ADDENDUM NO. 1 ELEMENTARY ADDITION TO SUMTER CENTRAL HIGH SCHOOL

Architect Job No. 24-38 July 24, 2024 DCM # 20240619

PROJECT:	PROJECT NO.	REFERENCE:
ELEMENTARY ADDITION TO SUMTER CENTRAL HIGH SCHOOL	24-38	ADDENDUM NO. 1
ARCHITECTURAL ADDENDUM DRAWING	DATE:	SHEET NO.
ANCHITECTORAL ADDENDOW DRAWING	7/10/2024	ADD 1

1 NON-PRESSURE PIPING - FLOOR PLAN - PART C

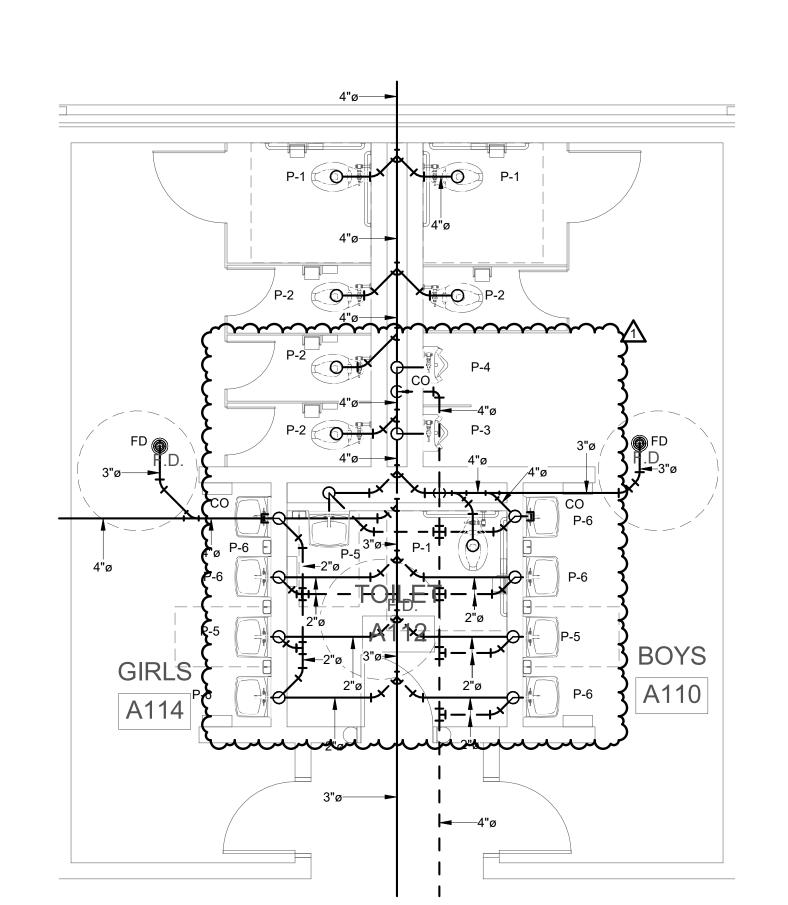
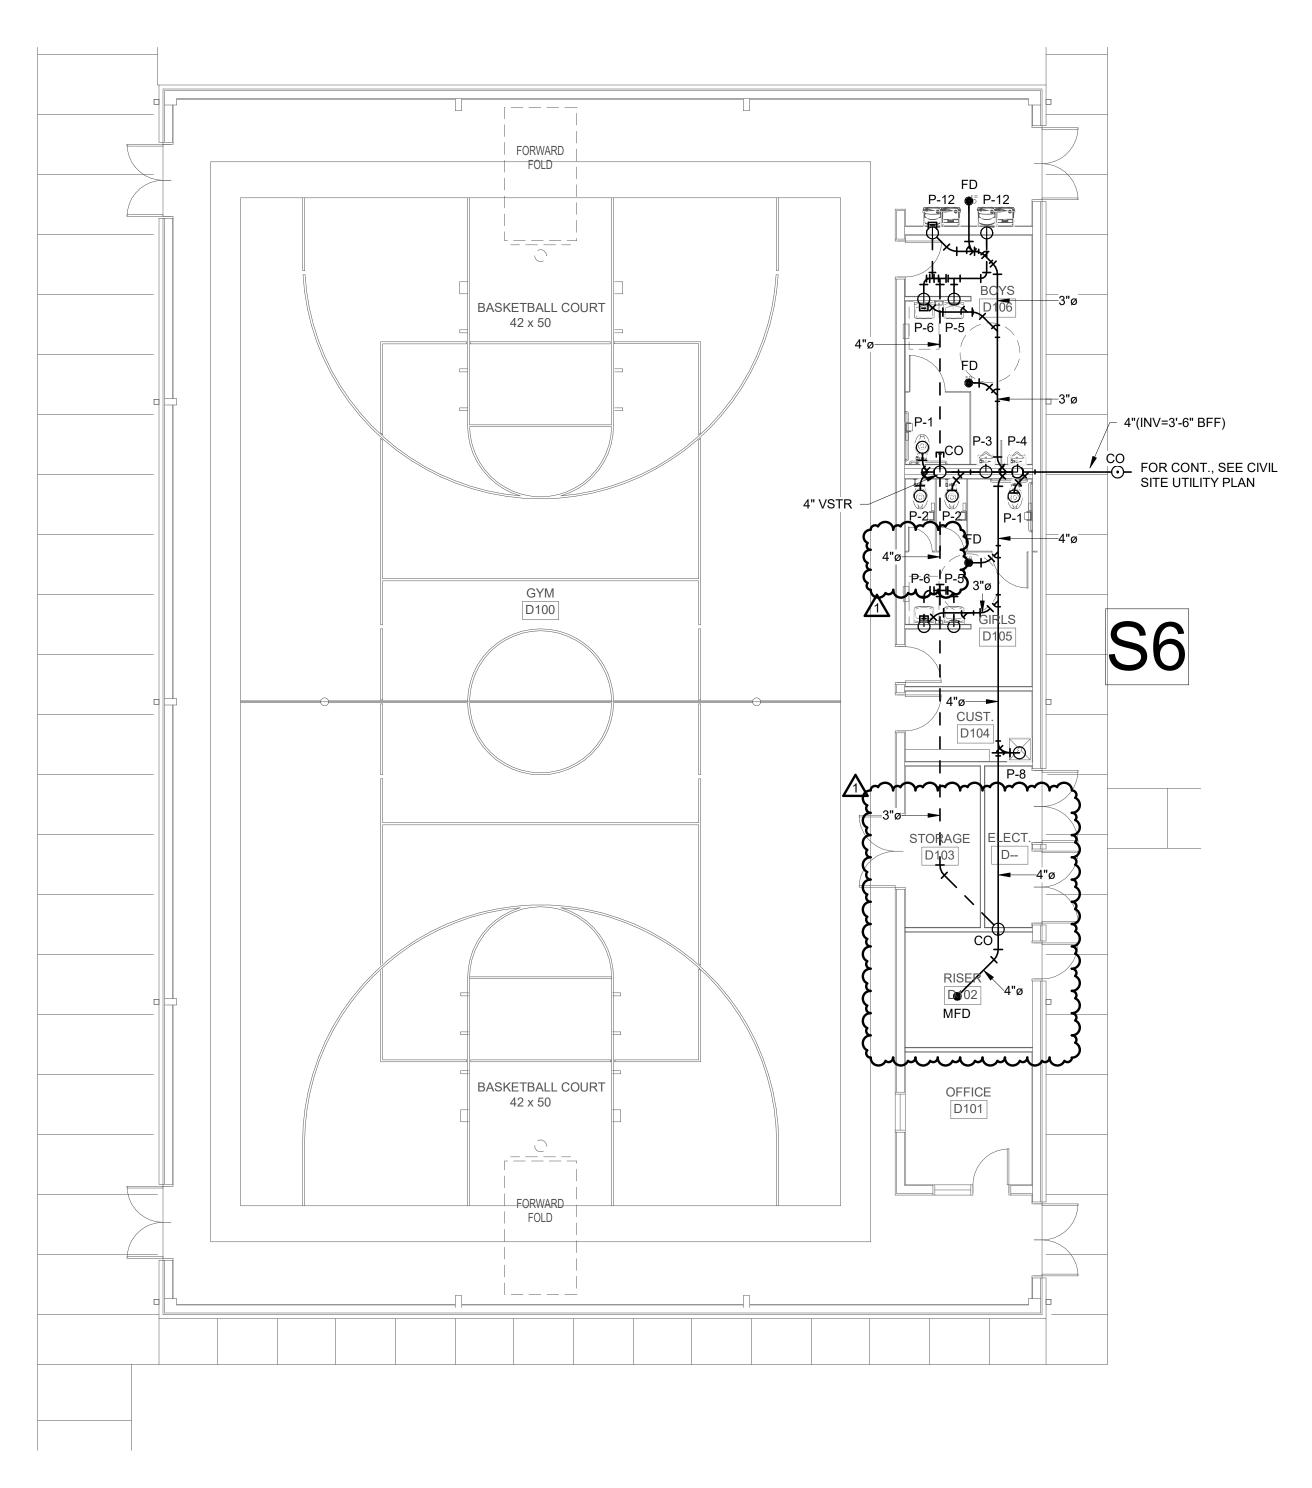
- 19. See attached Sheet **P0.01** for revised Water Heater Schedule.
- 20. See attached Sheet P1.0 for revised Non-Pressure Piping Floor Plan Part B.
- 21. See attached Sheet **P1.1** for revised Non-Pressure Piping Floor Plan Part C & Gym.

PRESSURE PIPING - FLOOR PLAN - PART A & B

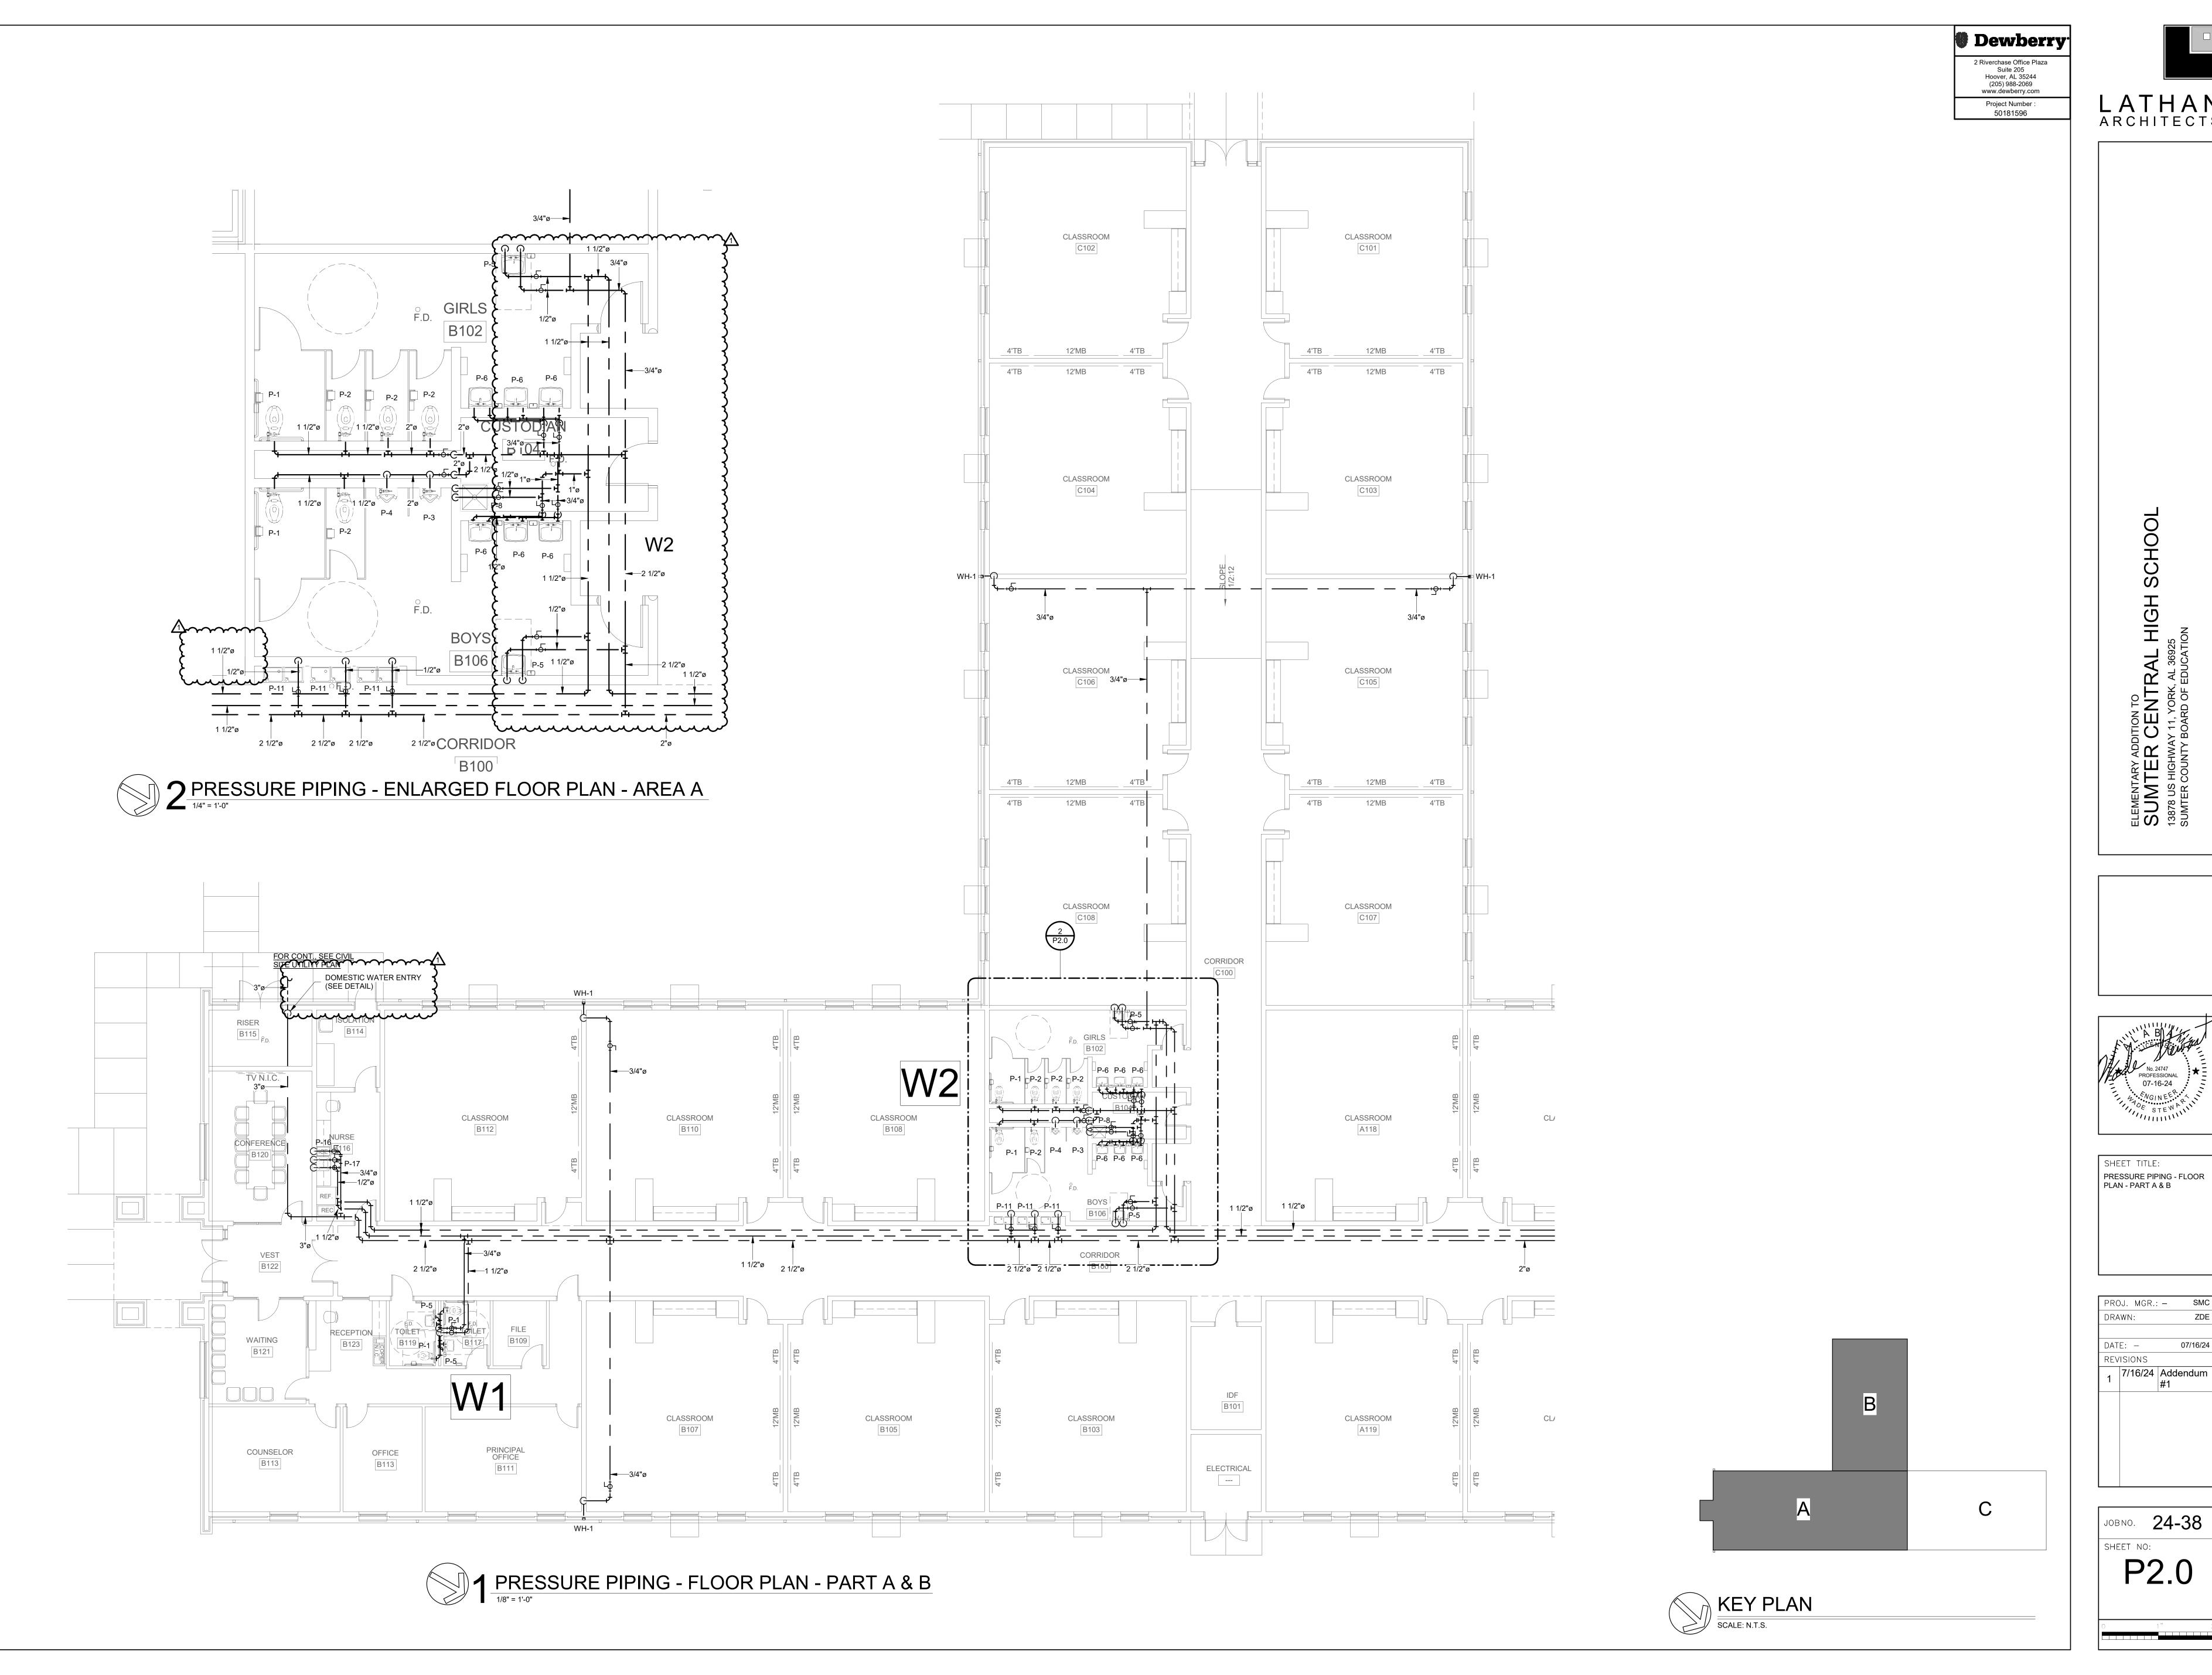
- 22. See attached Sheet **P2.0** for revised Pressure Piping Floor Plan Part A & B.

PRESSURE PIPING - FLOOR PLAN - PART C & GYM

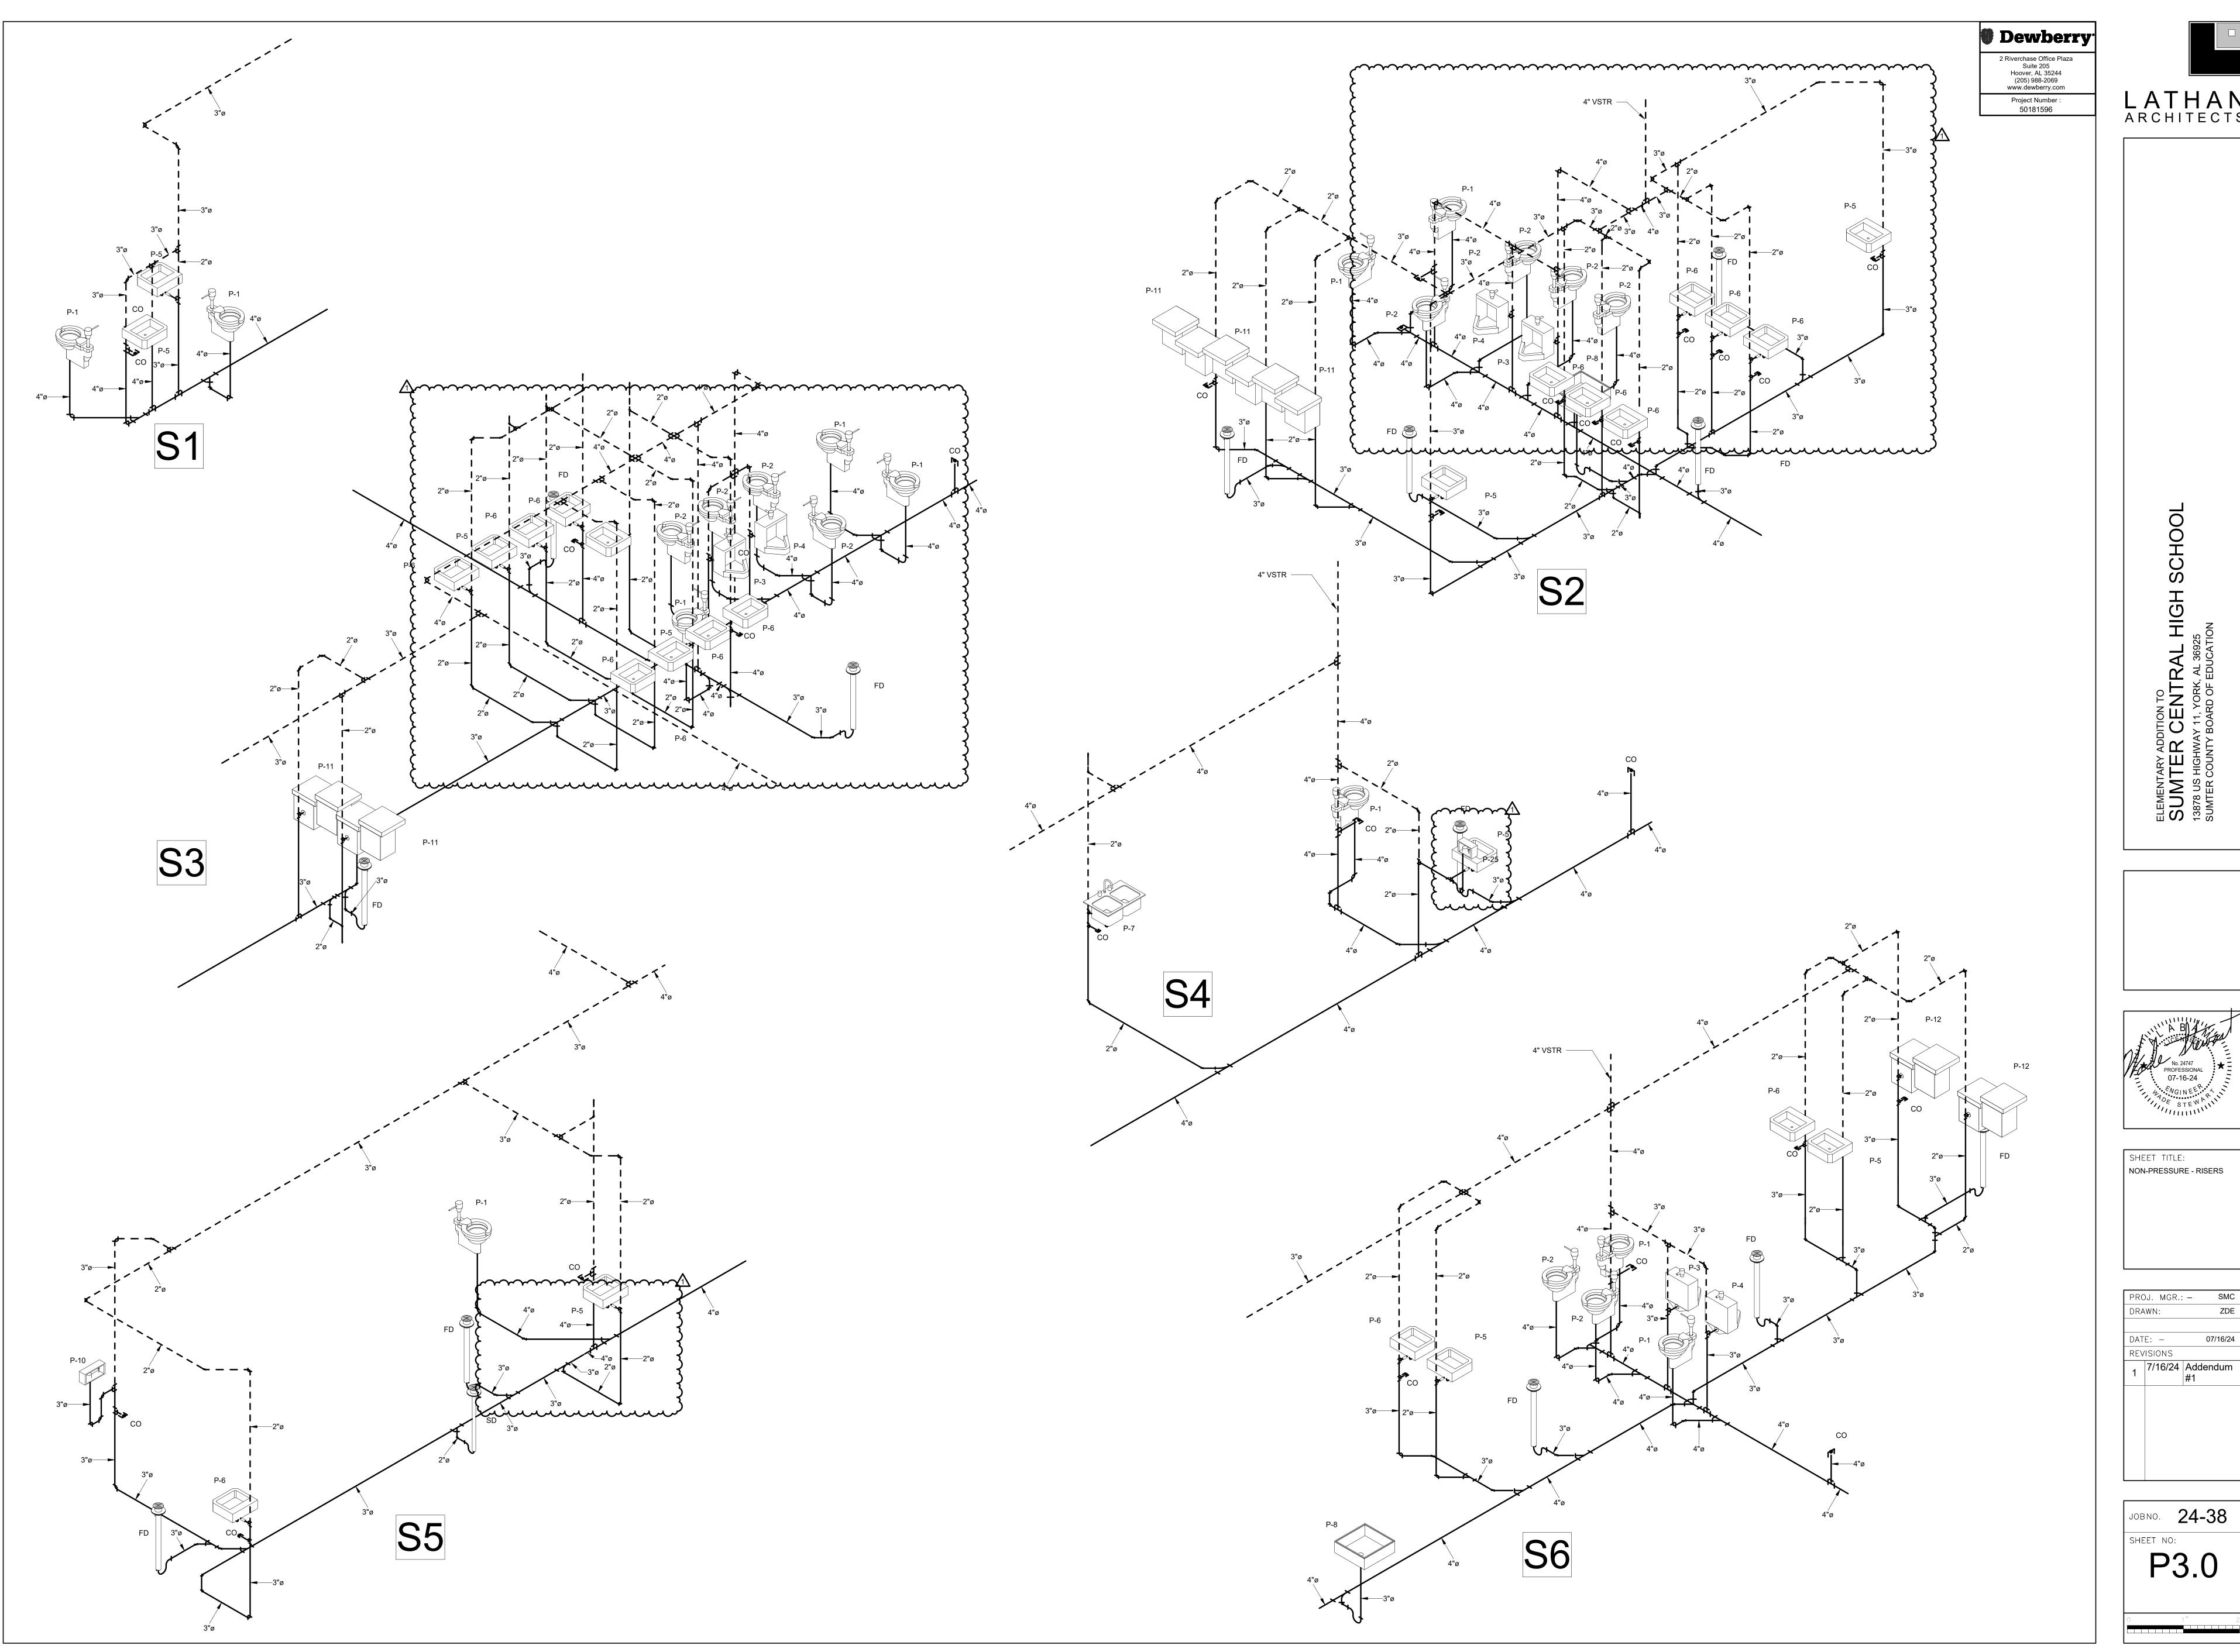
- 23. See attached Sheet **P2.1** for revised Pressure Piping Floor Plan Part C & Gym.
- 24. See attached Sheet **P3.0** for revisions to Non-Pressure Risers.
